BEST AVAILABLE COPY**PATENT COOPERATION TREATY****PCT****INTERNATIONAL PRELIMINARY REPORT ON PATENTABILITY**

Applicant's or agent's file reference P200401363 WO	FOR FURTHER ACTION	
	See Form PCT/IPEA/416	
International application No. PCT/DK2005/000196	International filing date (day/month/year) 22.03.2005	Priority date (day/month/year) 23.03.2004
International Patent Classification (IPC) or national classification and IPC INV. H01M8/22 H01M8/06 C01C1/02 B01D53/00 B01J20/00		
Applicant AMMINEX A/S

PCT/DK2005/000196

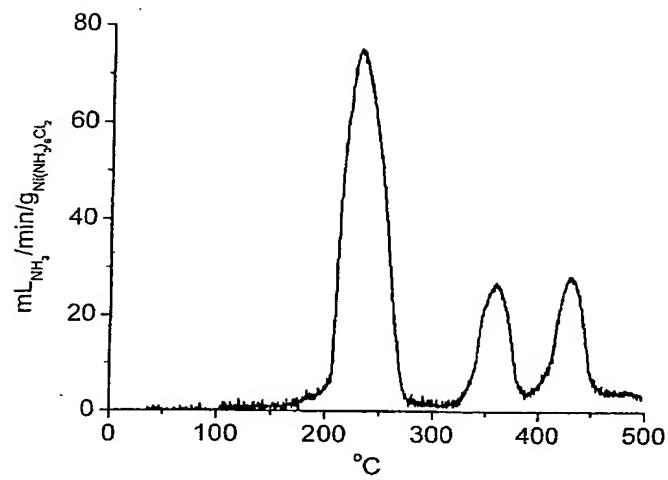
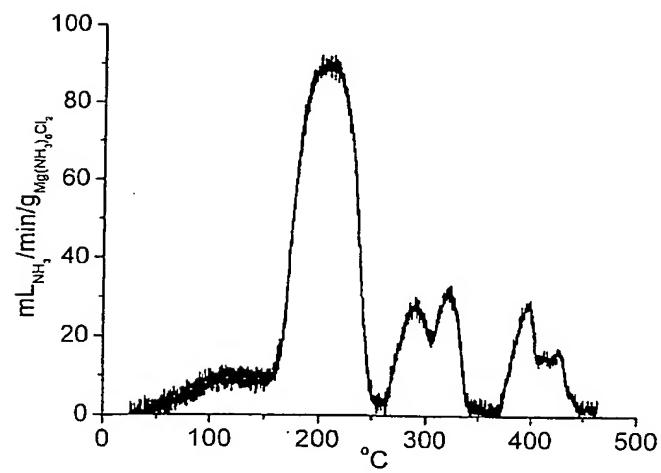
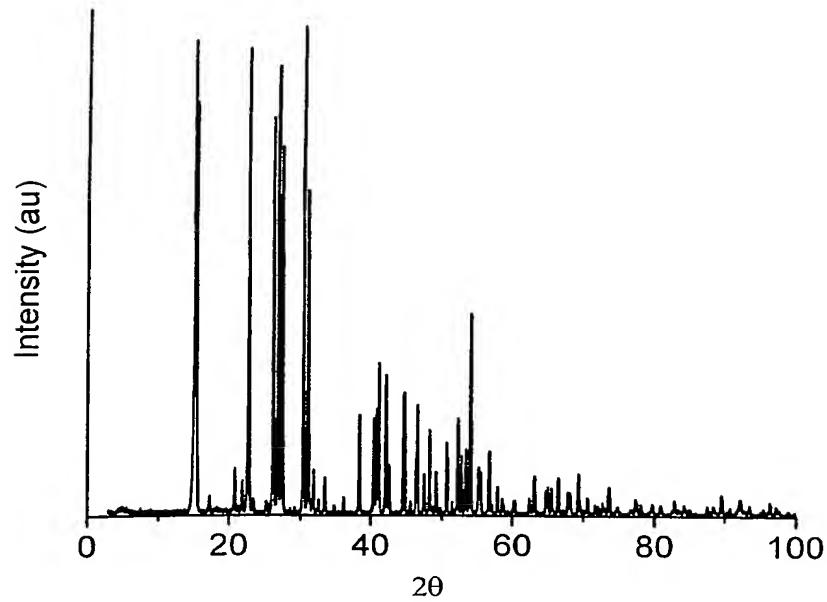
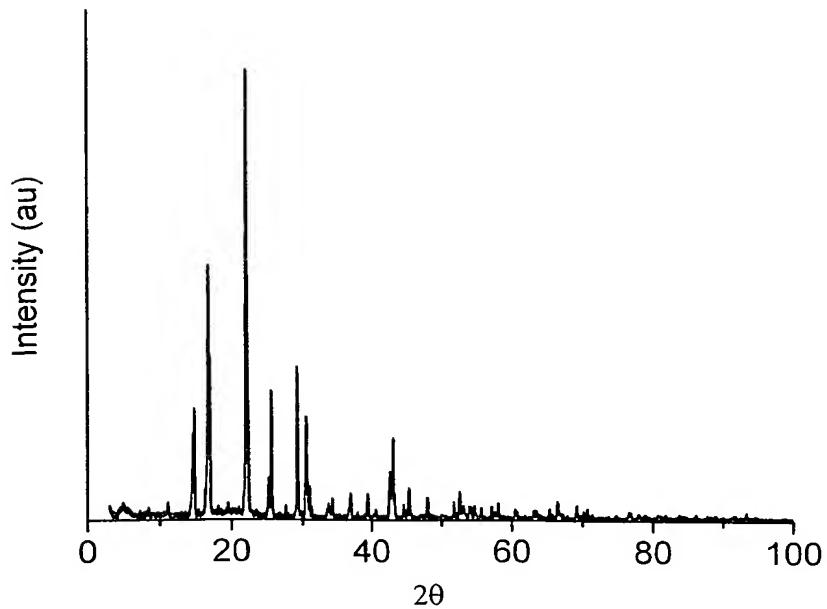
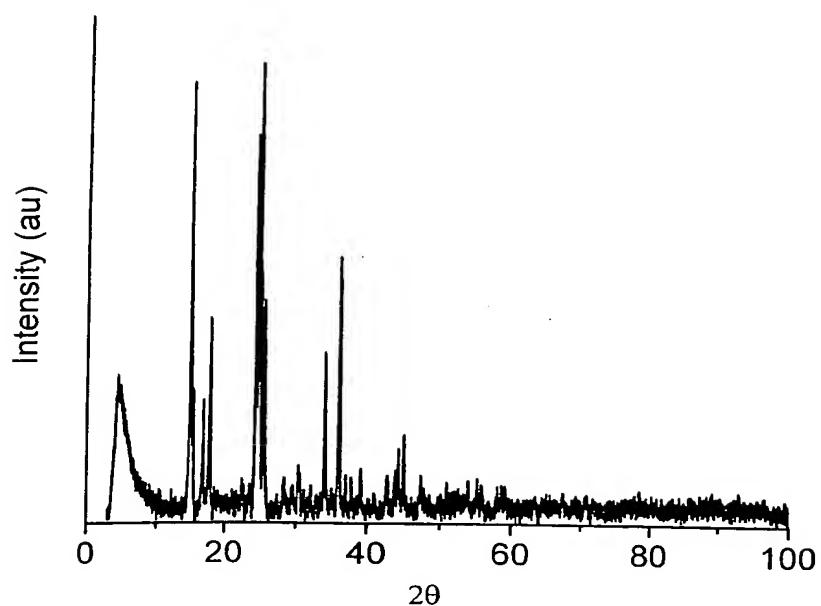
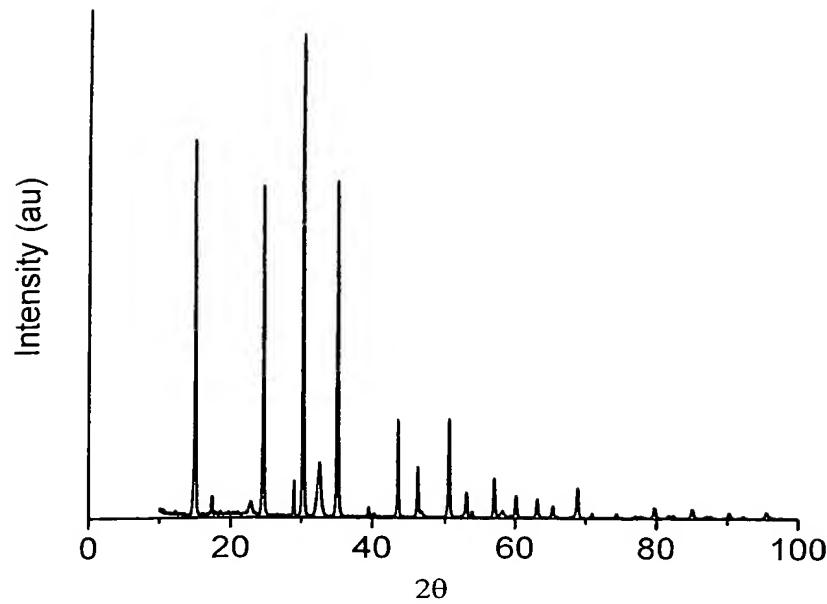
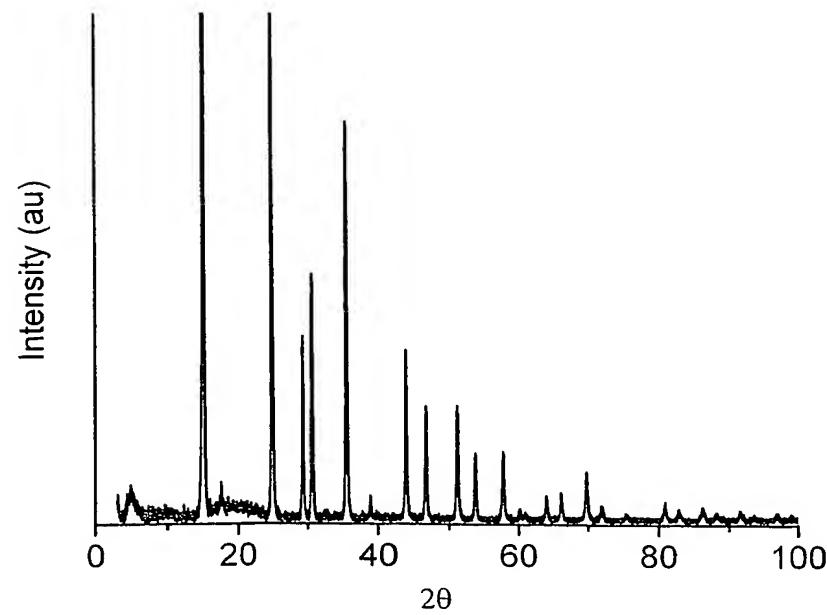
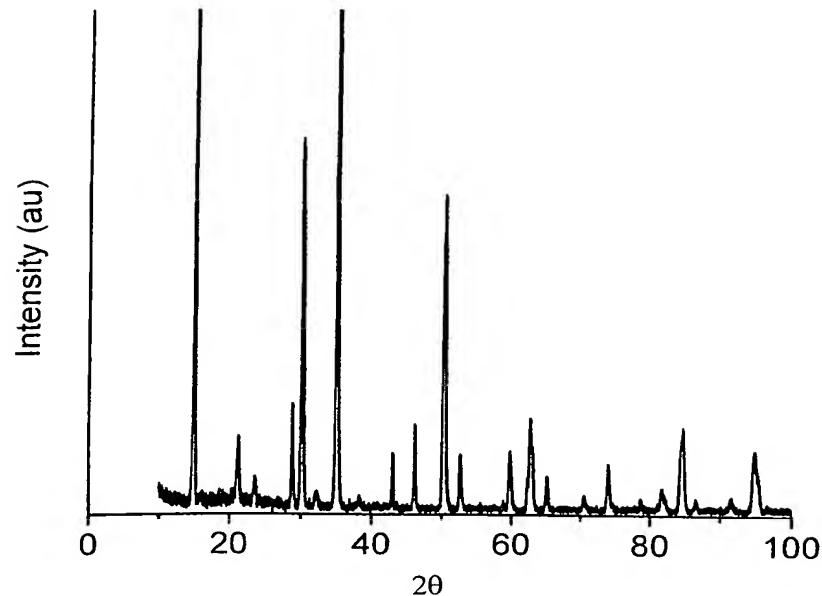
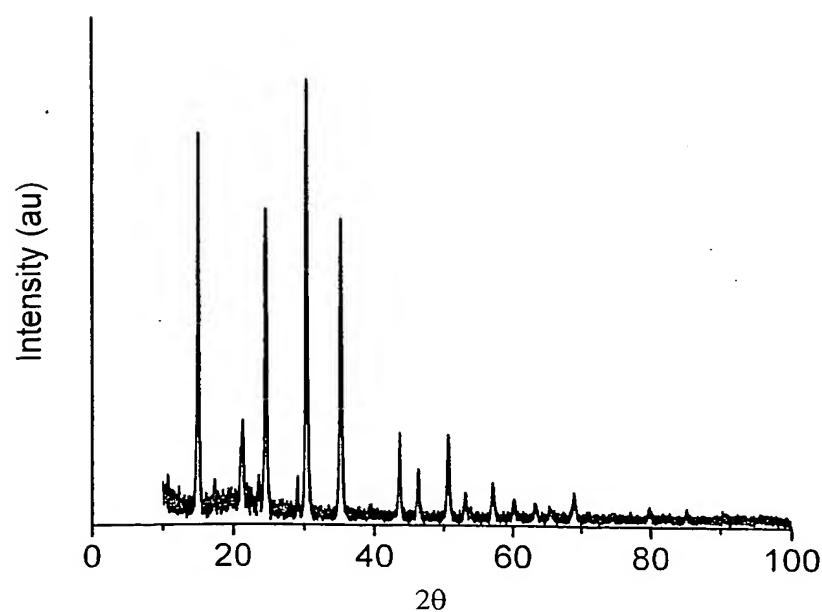
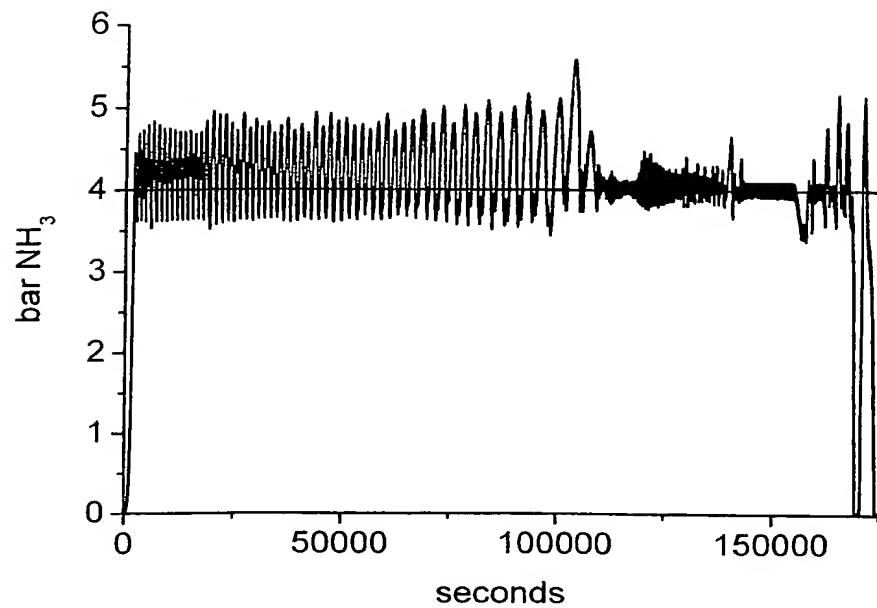
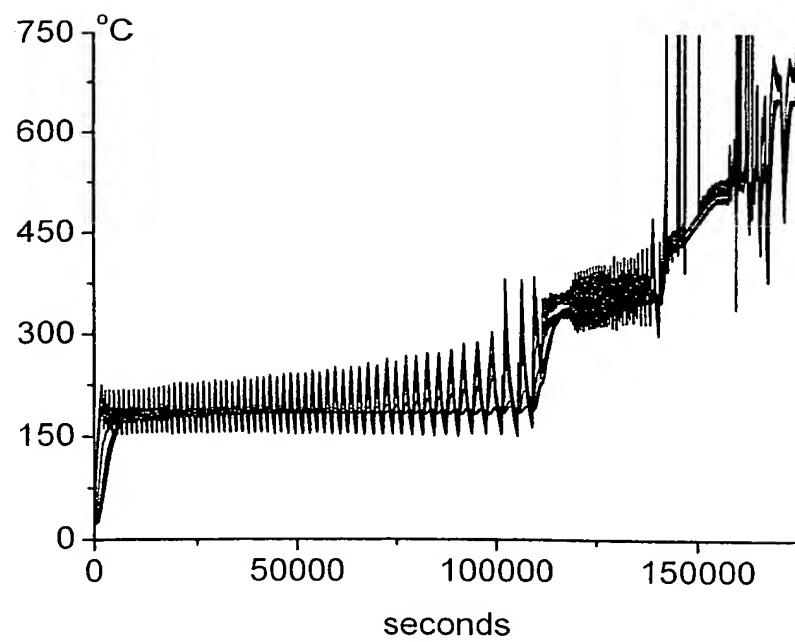
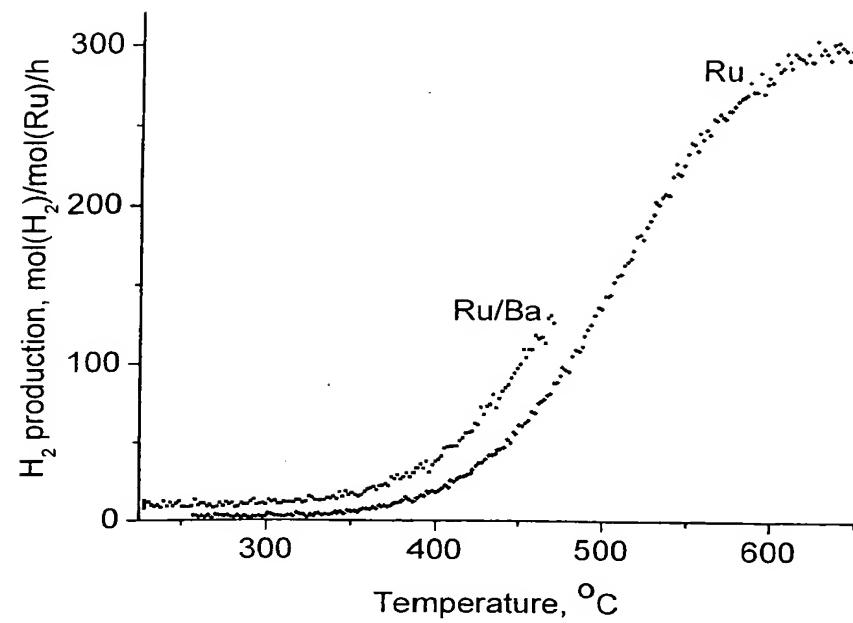
3.2 The numbering indicated for Figs. 4-15 does not match with the numbering used in pp. 20-22 of the description where they are indicated as Figs. A-L.
